Transmitter waveform

CI 130 SC 130.7.1.11 P 145 L 25 # 252

130.7.1.11 Transmitter output waveform requirements

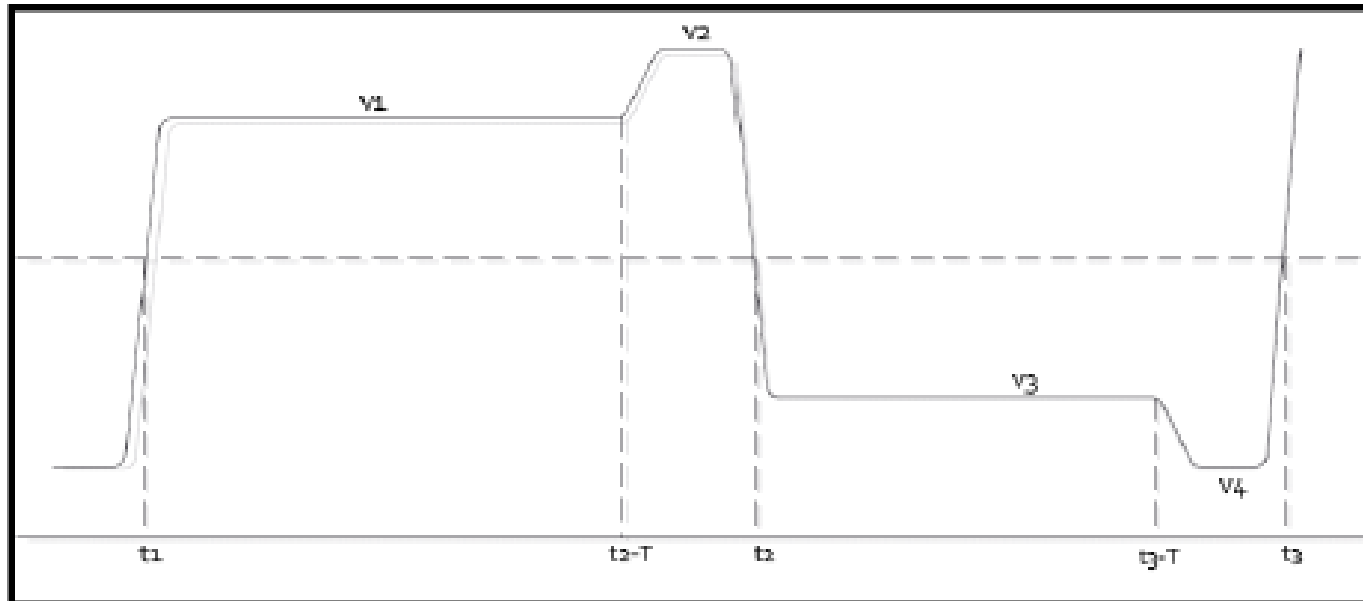
A procedure for the measurement of v1, v2, v3, and v4 (and Rpre) is provided but no requirements on the values of v1, v2, v3, and v4 (and Rpre) are given.

Include the requirements or, if there are no requirements,  move the subclause.

Proposed TX Electrical Requirement

V1 (mV)	220 to 600
Rpre	1.25 +/- 0.05
